**Response to Stakeholder Comments on Proposed Terms of Reference
Plexos Optimization Analysis / NSPI Thermal Fleet Retention
August 1, 2017**

Proposed Terms of Reference - Amended

Plexos Optimization Analysis

Cost-Effectiveness of Retaining NSPI Thermal Resources Through and Possibly Beyond 2030

Reserve Margin Results from Various Candidate Resource Plans – 2014 IRP (“Figure 3. Planning Reserve Margin by CRP”)

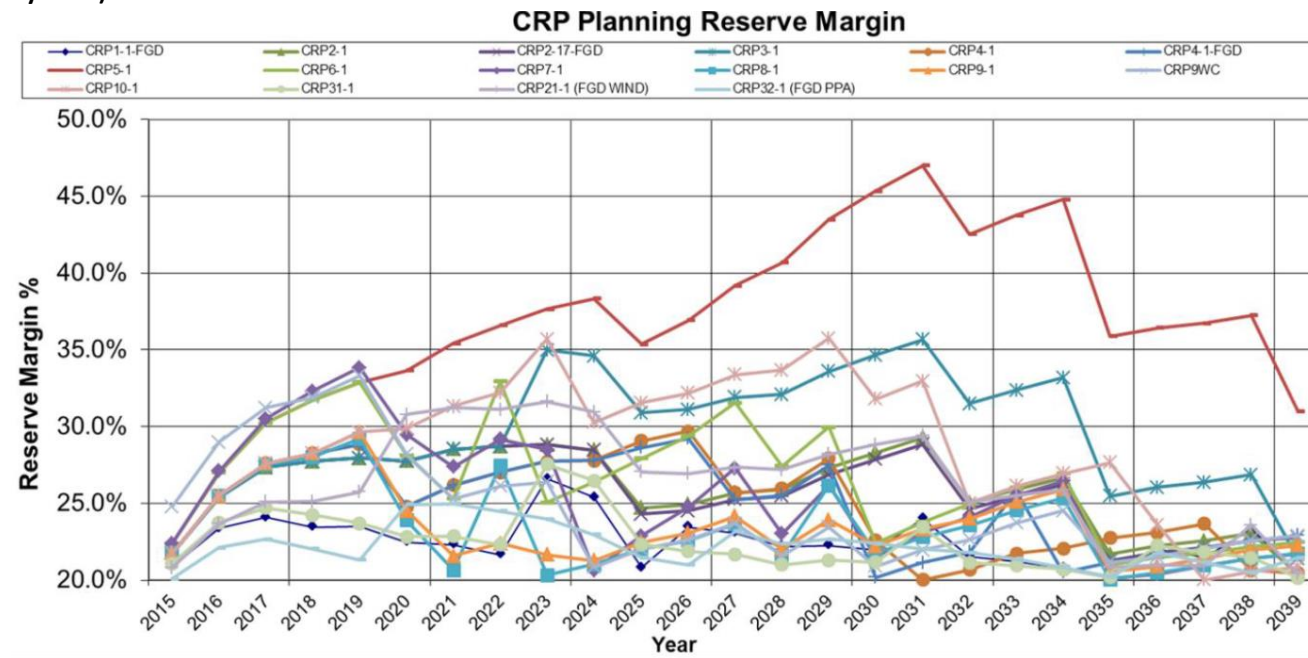
most of the economic options involved longer retention of coal units” (4/13/2017 presentation, slide 27). However, the 2014 IRP did not rigorously examine whether or not longer retention of the coal fleet was economically optimal.

Instead, the 2014 IRP analyses included - *as inputs* - assumptions for sustaining capital costs for each candidate resource plan. The resulting comparison of different plans did not account for the difference in surplus capacity associated with each plan. If the differences were minor, NSPI’s conclusion would not be unreasonable, subject to the certainty of sustaining capital cost assumptions. However, the differences were not minor – the plans with higher levels of peak load reduction resulted in surplus capacity levels that were significantly higher than those associated with lower peak load reduction plans, because no adjustment was made in sustaining capital contribution to allow for retirement of surplus capacity. This is shown in the graph below from the IRP report.

This critical aspect of the 2014 IRP analysis illustrates that NSPI’s conclusion, as re-stated at the 4/13/2017 technical conference, is not well-supported. It is not at all clear that lengthy retention of the coal units was the most economic option arising from the 2014 IRP analysis.⁶

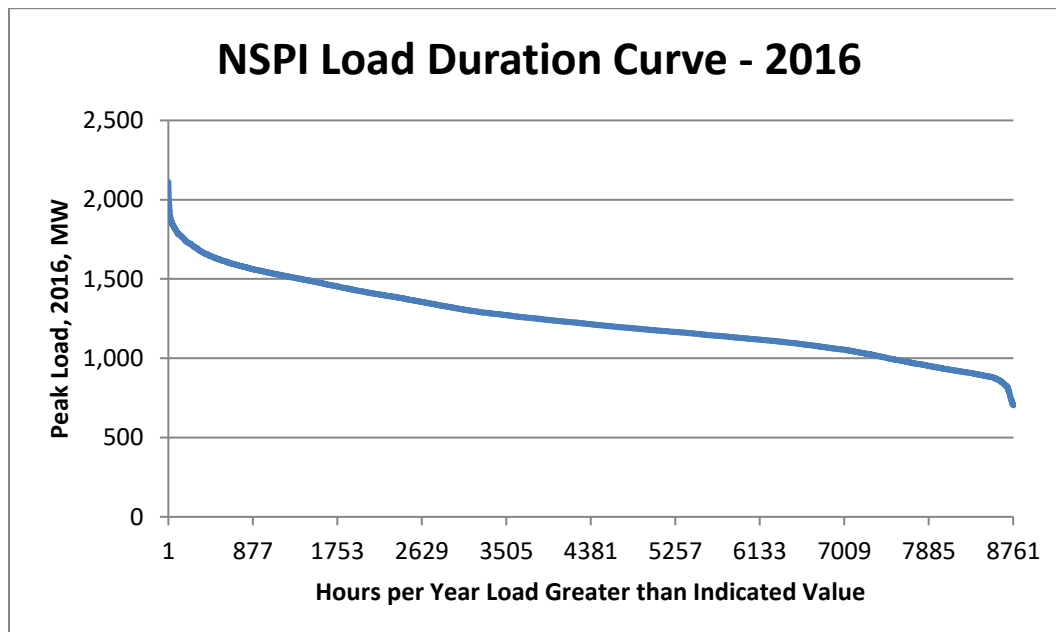
NSPI continues to utilize relatively small winter capacity credits for wind resources. The overall effect of NSPI’s approach is to value the aggregate wind capacity in Nova Scotia at 12%, significantly lower than New Brunswick’s use of 20% for resource planning purposes, and lower than Northern Maine’s use of 26% to 46% of capacity and Quebec’s use of 30%.¹³ The contribution of wind resources to capacity requirements must continue to be carefully examined; if Nova Scotia was to use a capacity credit of 20%

for all its wind resources, the overall increase in contribution towards resource adequacy requirements would be on the order of 48 MW.¹⁴
